ABDO EAST COMMERCIAL TRACT MASTER DEVELOPMENT PLAN

Re: Abdo East Commercial Tract

MDP #015-06

The City Staff Development Review Committee has reviewed Abdo East Commercial Tract Master Development Plan **M.D.P. #015-06**. Please find enclosed a signed copy for your files. Your plan was accepted however please note the following:

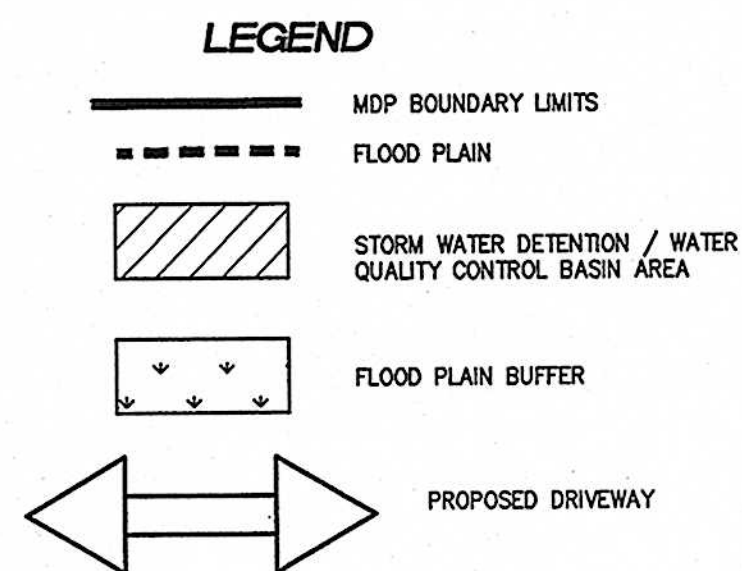
- In consideration of public safety and convenience, excessive grades by reason of topography should be avoided in street layouts and arrangements.
- Any access and R.O.W. issues along state facilities will need to be resolved with the **Texas Department of Transportation (TXDOT)**. For information about these requirements you can contact TXDOT at 615-5814.

- Driveway throat lengths shall comply with UDC 35-506, Table 506-7 requirements
 - All commercial driveways for this project shall comply with UDC §35-506, (r) Access and Driveways

- All access driveways shall provide clear sight distance along IH 10 Frontage Road to provide adequate obstruction free viewing distances for approaching traffic. All signage, landscaping, and improvements shall be selected and located so as to not block these clear sight distance areas.

- The developer shall be responsible for providing right-turn deceleration lanes with storage lengths and bay taper in all the driveway access points approved by TX DOT as it relates to the submitted TIA traffic counts, (Uniform Development Code (UDC) – 35-502(a)(7), subsection C.)

- Texas Department of Transportation (TX DOT) will determine access point along frontage road.

- **Trees** approves with the following conditions:
 - 2003 Tree Preservation ordinance standards per UDC Section 35-523 – a Tree Preservation Plan is required prior to any work on site. This can be submitted either as a site work permit or at the platting stage

- Streetscape standards per UDC Section 35-512 – IH-10 requires streetscape on existing ROW (plat will require note stating “Streetscape planting must be done at time of construction in accordance with section 35-512 of the UDC”)

- **Parks** recommends approves with the following conditions:
 - If the owner elects to pursue a multi-family development at the time of platting then supplemental information must be provided to this department in order to determine Park Dedication requirements

- It will be expected that you will plat all of the property depicted in your Master Development Plan (M.D.P.) to include floodplains, drainage areas and open space.
